10/553064

**Response to Office Action Mailed March 20, 2007**

Fig.1

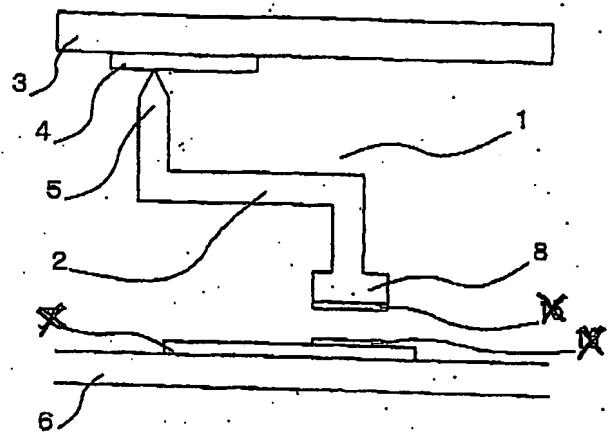
The Examiner indicated that some of the reference characters that appear in the figures are not mentioned in the specification. For clarification, Applicant has deleted reference character 11 from figures 2-4, and reference characters 7, 15, and 16 of figure 1 from the figures.

Applicant has included a marked-up copy of the figures indicated the changes made and replacement sheets for these figures.

Fig.5  
(PRIOR ART)

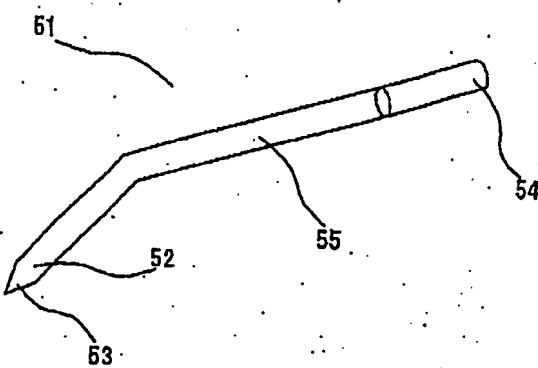
The Examiner has objected to Figures 5-6A-B, indicating that the figures should be designated by a legend such as "Prior Art." Applicant has submitted replacement sheets for all figures. The legend "Prior Art" has been added to Figures 5-6A-B.
